**SUBJECT: VILLAGE OF HOFFMAN ESTATES  
ARIZONA BOULEVARD STORM SEWER REPLACEMENT PROJECT  
ADDENDUM NO. 1**

Arizona Boulevard Storm  
Sewer Replacement Project  
Village of Hoffman Estates

Details

**SUBJECT: VILLAGE OF HOFFMAN ESTATES  
ARIZONA BLVD STORM SEWER REPLACEMENT PROJECT**

1 Manhole Detail (Not to Scale)

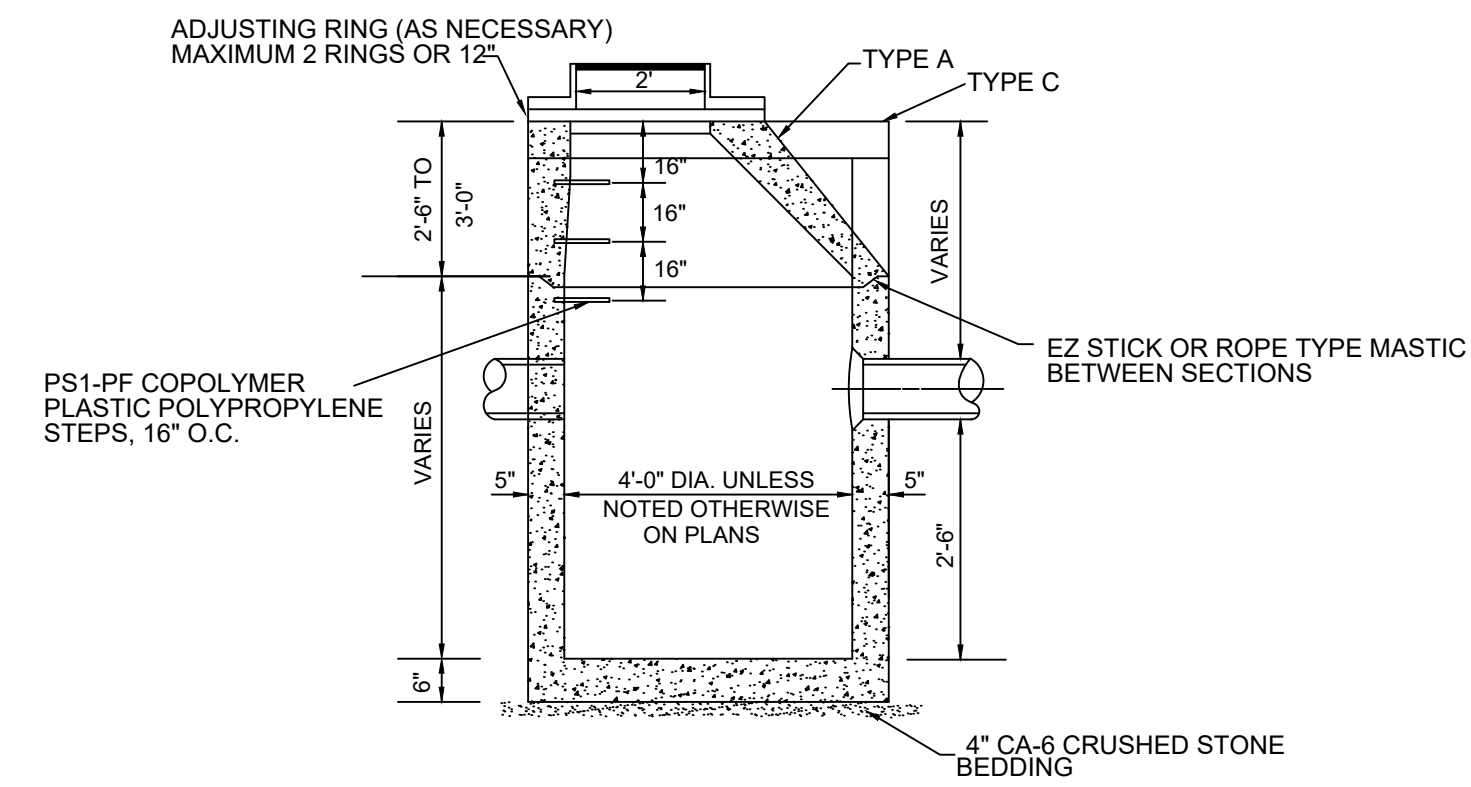
1. The "DETAILS" sheet C6.1 has been revised to reflect changes to the details for Manhole, Catch Basin, and Inlet. Replace Sheet C6.1 dated 3/2/2022 with revised Sheet C6.1 Addendum #1 dated 3/10/2022.
2. The "DETAILS" sheet C6.2 has been revised to add the detail for Weephole. Replace Sheet C6.2 dated 3/2/2022 with revised Sheet C6.2 Addendum #1 dated 3/10/2022.

4. The details for storm sewer structures require "boots" for all sewer pipe connections. Is this correct?  
*No, Addendum #1 revises the details for storm sewer structures; manhole, catch basin, and inlet.*

1. ONLY PRECAST STRUCTURES ALLOWED.
2. MAXIMUM TWO (2) ADJUSTING RINGS, MAXIMUM TOTAL HEIGHT, TWELVE (12) INCHES.
3. MANHOLE SECTIONS TO BE JOINED WITH ROPE TYPE MASTIC (E-Z STICK OR EQUAL).
4. PRECAST CONCRETE BASE MUST BE INTEGRALLY CAST WITH THE LOWEST WALL SECTION.
5. ALL GRATES PROVIDED SHALL BE BICYCLE SAFE.
6. ALL SANITARY SEWER MANHOLES SHALL HAVE A CHIMNEY SEAL FROM CRETEX OR APPROVED EQUAL.
7. ALL STORM STRUCTURES LOCATED IN THE PAVEMENT SHALL FOLLOW THE WEEPHOLE DETAIL.

2 Trench Backfill Detail (Not to Scale)

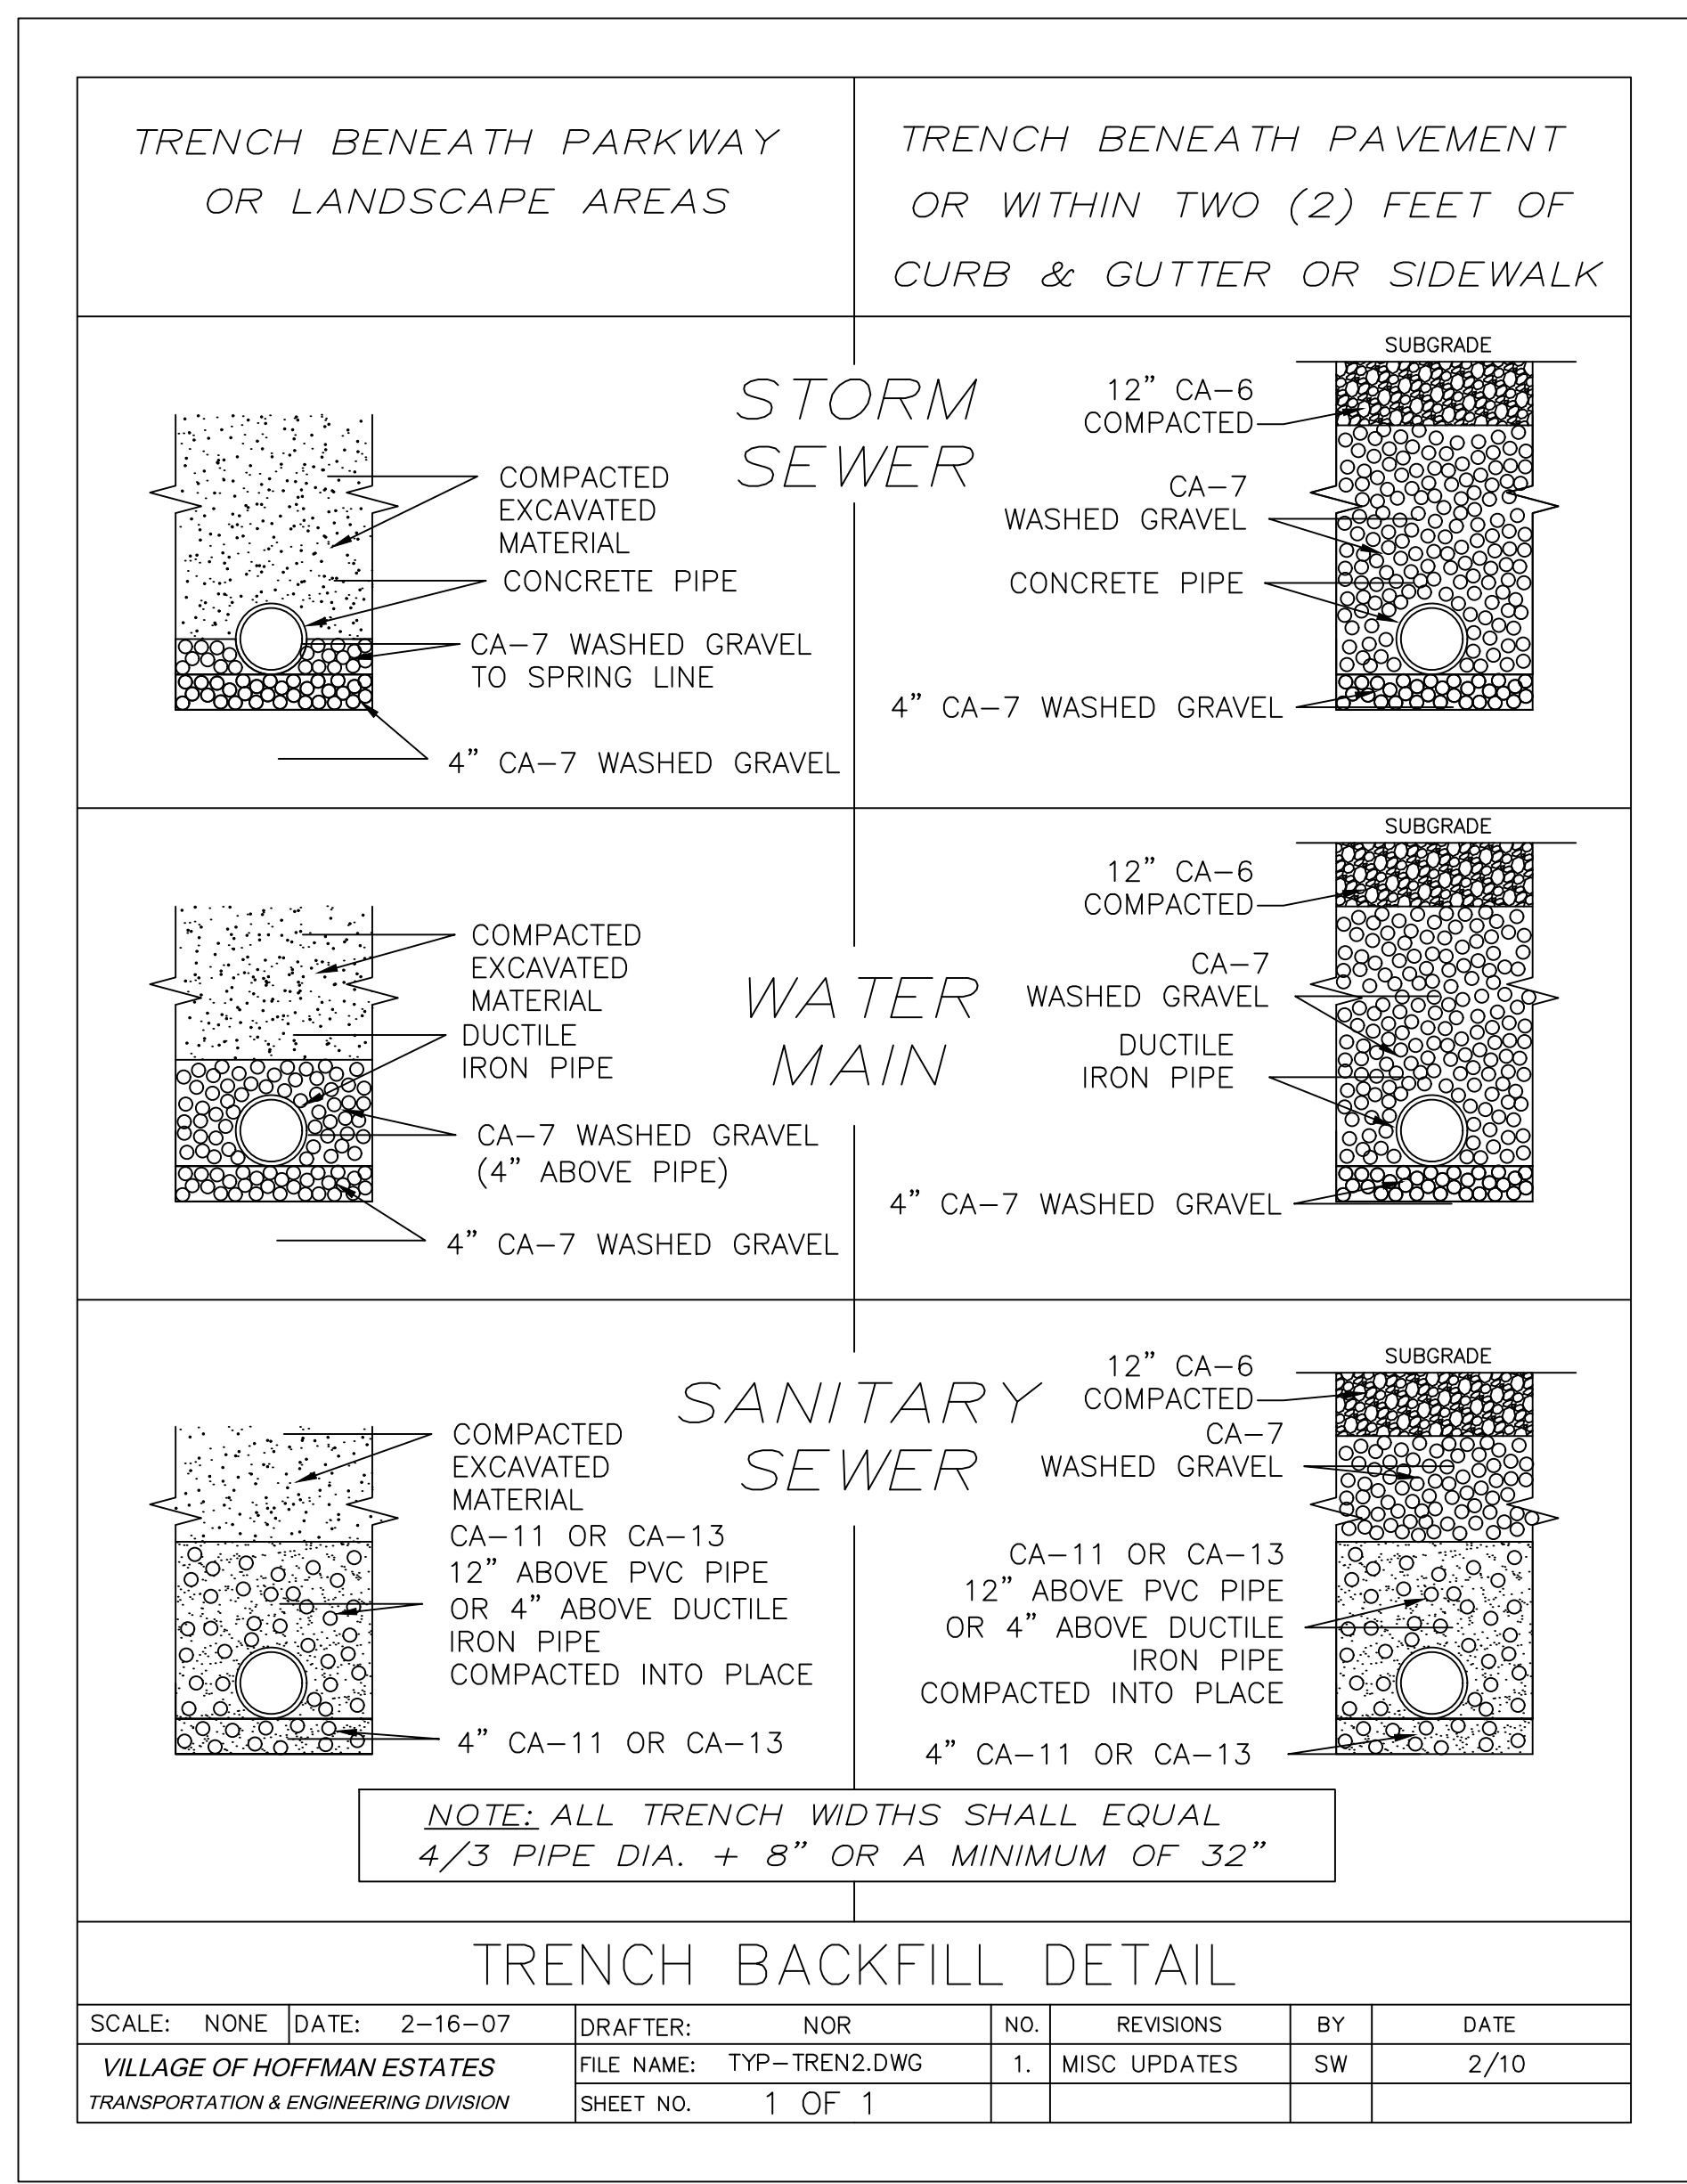
1. Trench Backfill specification does not state materials to be used for Trench Backfill. Detail on Sheet C6.2 calls for CA-7. Is this correct?

2. Is Trench Backfill included in the unit cost for Water Service Line.

*Yes, Trench Backfill materials specified for the project is CA-7 as per Trench Backfill detail.*

*Yes, the Special Provision for Water Service Line states that the unit price shall include "all work necessary to complete the work", including Trench Backfill. See Trench Backfill Detail..*
